**Department of Energy**  
Carlsbad Field Office  
P. O. Box 3090  
Carlsbad, New Mexico 88221

Subject: Notification of Planned Change to the Permitted Facility, Hazardous Waste Facility Permit, Number: NM4890139088-TSDF

Supplemental Ventilation System  
(Conceptual Drawings Only)

Auxiliary Fan

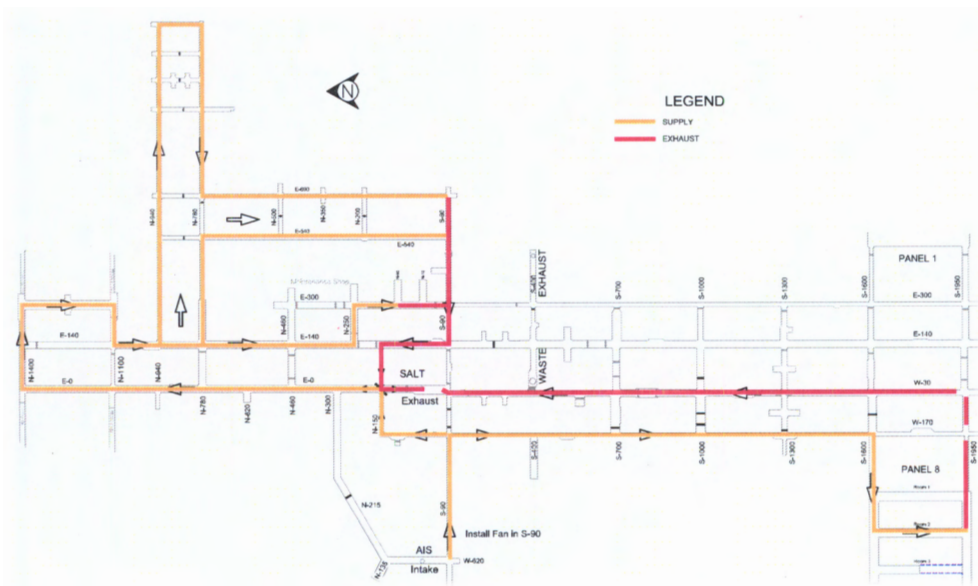
The SVS consists of an auxiliary fan installed in the S-90 drift to provide additional ventilation air to the underground. The SVS system is designed to work in conjunction with the Interim Ventilation System. Supplemental ventilation is needed to facilitate underground recovery activities such as maintenance activities in the north area, mining, drilling, bolting and salt handling. Use of the SVS will minimize dust particulate loading on the High Efficiency Particulate Air (HEPA) filters since the construction split will take clean air from the surface and will exhaust salt dust laden air directly through the Salt Handling Shaft. Ventilation air through the disposal area will continue to be routed through HEPA filtration. Conceptual drawings depicting the SVS auxiliary fan and underground ventilation flow paths are enclosed for information.
